UNITED STATES PATENT AND TRADEMARK OFFICE

APPLICATION NO.	FILING DATE	FIRST NAMED INVENTOR	ATTORNEY DOCKET NO.	CONFIRMATION NO.
10/707,619	12/24/2003	Aaron Golle	1748006US1	1478
21186	7590	06/08/2006	EXAMINER	
SCHWEGMAN, LUNDBERG, WOESSNER & KLUTH, P.A.			HAN, JASON	
P.O. BOX 2938			ART UNIT	
MINNEAPOLIS, MN 55402			PAPER NUMBER

Office Action Summary	Application No. 10/707,619	Applicant(s) GOLLE ET AL.	
	Examiner Jason M. Han	Art Unit 2875

DETAILED ACTION

FIG 1

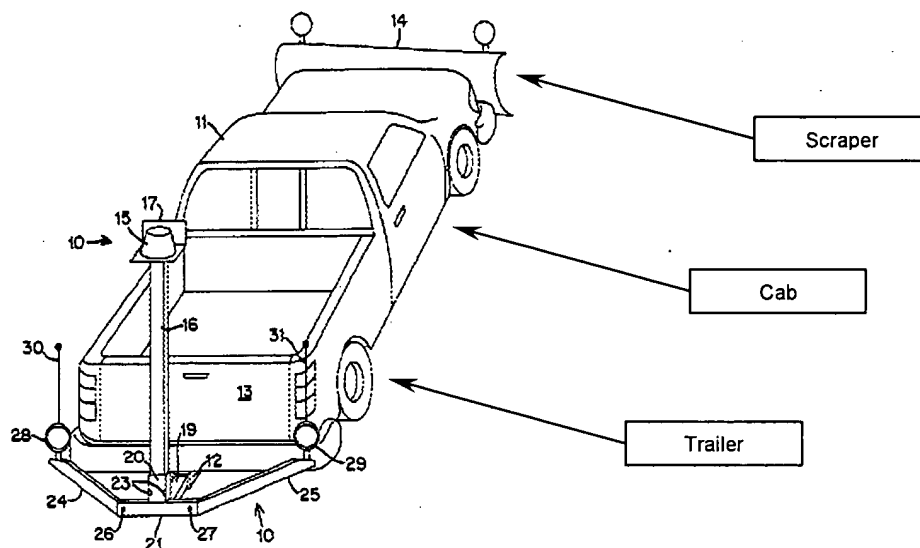
With regards to Claim 1, Pratt discloses a warning light for a vehicle, whereby the vehicle is a snowplow including a cab, trailer, and scraper [Figure 1 – note drawing below].

Pratt does not specifically teach the warning light being an EL lighting including an EL portion being a first color in a non-illuminated condition, and a second color in an illuminated condition, and wherein a tinting layer is tinted so that when the EL portion is non-illuminated the tinting causes the sign to produce a first color different than the color of the EL portion in the non-illuminated condition, and so that when the EL portion is illuminated the tinting causes the EL lighting to produce a second color different than the first color and different than the color of the EL portion in the illuminated condition.

It would have been obvious to one ordinarily skilled in the art at the time of invention to modify the warning light of Pratt to incorporate the EL safety lighting of Burrows in order to provide various designs and warning systems with various illumination and non-illumination colors, since it “will thus be appreciated that limitless design possibilities arise for interrelating the lit and unlit appearances of the lamp by printing down various colorized phosphor zones in combination with various tinted zones” [see Burrows: Column 10, Lines 4-8]. It is also obvious that one could incorporate the warning/EL safety lighting onto the cab of a snowplow, since Hoffman teaches an EL light device [Figure 1], and discloses, “While the discussion of the invention has emphasized its use in connection with motor vehicles, specifically automobiles, signs according to the invention could also be mounted on trucks,

boats, and the like, or on articles of clothing or the like, where not otherwise limited [Column 6, Lines 3-7]”. Providing the modification of incorporating the EL light device onto the cab would thus convey a message [e.g., safety or warning] or enhance visibility to other individuals/vehicles of the presence of the snowplow, further improving overall safety and prevent an accident. Lastly, it should be noted that it is commonly known and obvious within the art to use signs on large vehicles to increase awareness of drivers and avoid accidents.
